PRODUCT CHANGE NOTIFICATION (PCN)

A-MCUP-80005/B
MODULAR CABLE

CHANGE NOTIFICATION: PCN 20220425_A-MCUP-80005/B

DESCRIPTION OF CHANGES:
CHANGE OF DATA SHEET
CHANGE OF DATA SHEET
New Draw.-No. ASS_7407_CArev04

A-MCUP-80005/B OLD VERSION	A-MCUP-80005/B NEW VERSION

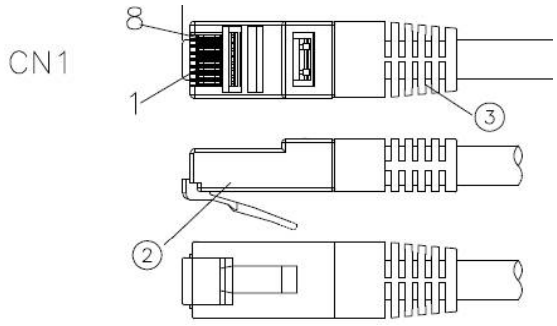
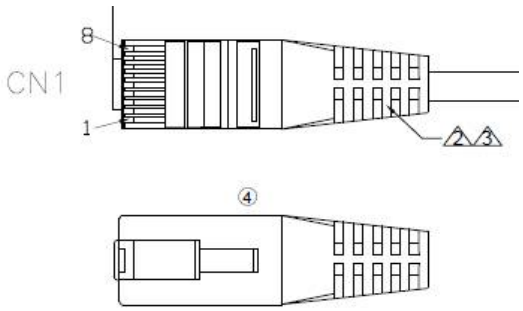
NO.	NAME.	Q'TY	SPECIFICATION
③	Molding PVC	2	Molding PVC 45P
②	RJ45 CONN	2	RJ45 8P8C,Two Fork gold plated contacts 3u" gold
①	CABLE	1	UTP(26AWG*x1PR)*4+PVC OD:4.9±0.2mm

NO.	NAME.	Q'TY	SPECIFICATION
④	⚠3 Molding PVC	2	Molding PVC 65P
④	⚠2 RJ45 CONN	2	RJ45 8P8C, contacts 3u" gold-plated Un-shielded PC UL94V-2
④	⚠1 CABLE	1	CAT 5E U/UTP(26AWGx1PR)*4+PVC Jacket OD:4.9±0.2mm

Drawing-No.
ASS 7407 CA

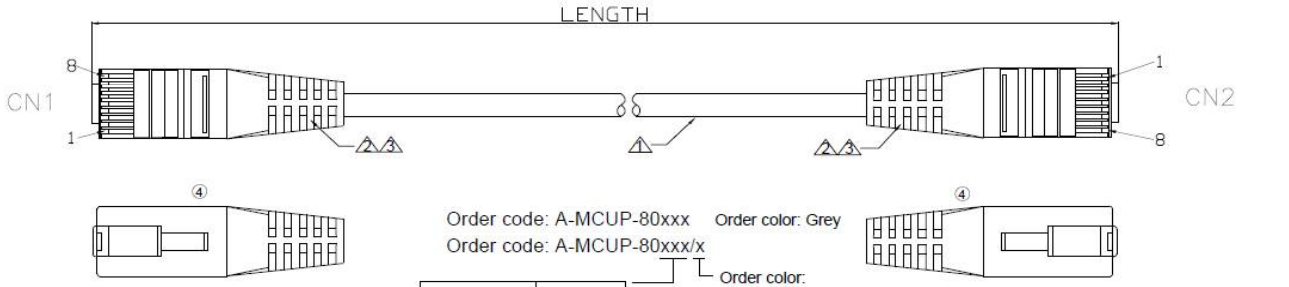
Id.	Modification	Date	Name
④	Change the plant	12.04.2022	Luca
③	Clarify the tolerance	23.08.2018	Segal
②	Add the new P/N for black outer jacket	01.11.2017	Winnie
①	Add the product type of length and color	04.08.2017	Fred
⓪	Drawn	25.05.2014	Joanna

NO.	NAME.	Q'TY	SPECIFICATION
④	⚠3	3	Molding PVC	2	Molding PVC 65P
④	⚠2	2	RJ45 CONN	2	RJ45 8P8C, contacts 3u" gold-plated Un-shielded PC UL94V-2
④	⚠1	1	CABLE	1	CAT 5E U/UTP(26AWGx1PR)*4+PVC Jacket OD:4.9±0.2mm
